Access Compliance Report

Public Rights-of-Way

Intersection ID: 10844	Main Street: W_5TH_ST	Cross Street: FRAZIER_AV	Location: W
ADA ID: BA0C59FE625F	Ramp Type: PerpDiag	Initial Pass/Fail: Fail	Overall Compliance: No
		Severity Score: 42.5

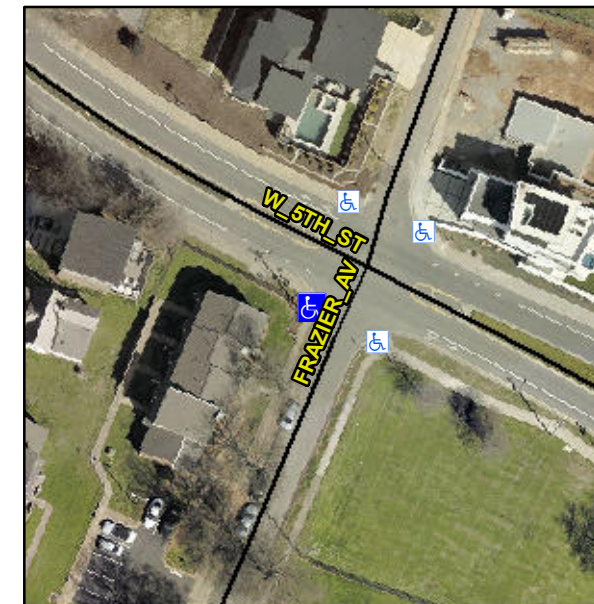
Not Found, R304.5.1, R304.2.2, R304.5.3

Compliance	Description	Data	Compliance	Description	Data
N/A	Ramp Length (in)	58.5	No	Ramp Slope (%)	9.0
No	Ramp Width (in)	33.5	No	Ramp XSlope (%)	6.6
N/A	Flare Type LT	N/A	N/A	Flare Type RT	N/A
N/A	Flare Slope LT (%)	N/A	N/A	Flare Slope RT (%)	N/A
N/A	Flare Traversable LT?	N/A	N/A	Flare Traversable RT?	N/A
N/A	Landing Length (in)	N/A	N/A	DWS Provided?	N/A
N/A	Landing Width (in)	N/A	N/A	DWS Contrast?	N/A
N/A	Landing Slope (%)	N/A	N/A	DWS Length (in)	N/A
N/A	Landing X Slope (%)	N/A	N/A	DWS Full Width?	N/A
N/A	Landing Curb? (Y/N)	N/A	N/A	DWS Offset (in)	N/A
N/A	Shared Landing?	N/A			
N/A	Gutter Ponding?	N/A	N/A	Gutter Slope (%)	N/A
N/A	Gutter Lip Ht (in)	N/A	N/A	Gutter X Slope (%)	N/A
N/A	Painted X Walk1?	No	N/A	Painted X Walk2?	No
	X Walk 1 Direction	To SE		X Walk 2 Direction	To NE
N/A	X Walk 1 Width (in)	N/A	N/A	X Walk 2 Width (in)	N/A
	X Walk 1 Slope (%)	4.1		X Walk 2 Slope (%)	5.0
	X Walk 1 X Slope (%)	4.0		X Walk 2 X Slope (%)	5.0

Remove & Replace Curb Ramp With Two New Directional Ramps or Equivalent.
